# Notice of Allowability

10/806,350

MIZUHASHI, HIROSHI

### EXAMINER'S AMENDMENT

Fig. 6

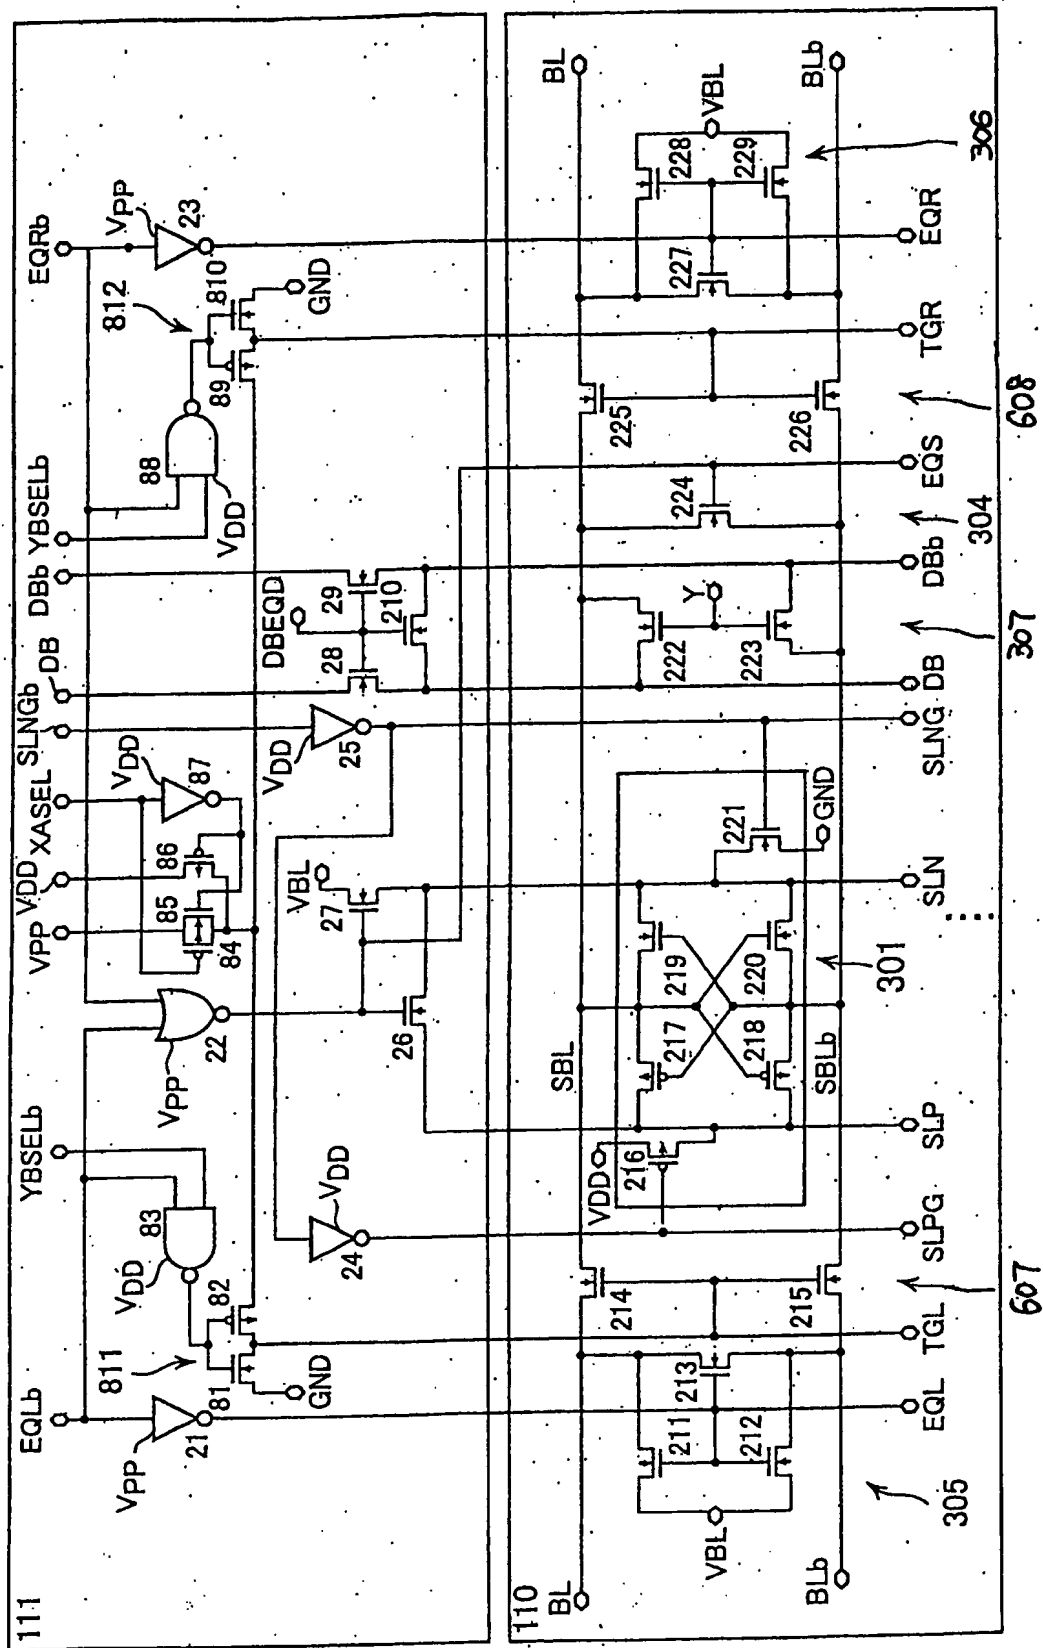
(Sakamoto, 6,445,632, does not teach the use of inverters 811 and 812, each being connected between ground and the respective voltage VPP via transistors 84

and 85 and the voltage VDD via transistor 86, for driving the corresponding switching transistors 214/215 and 225/226 in Fig. 6 of the present invention as recited in claims 1, 3-4, 8-9 and 13-14. Sakamoto, 6,445,632, does not teach the method specifically recited in claim 18 which corresponds to the disclosure recited in last paragraph of page 10 and first line of page 11 of the specification).
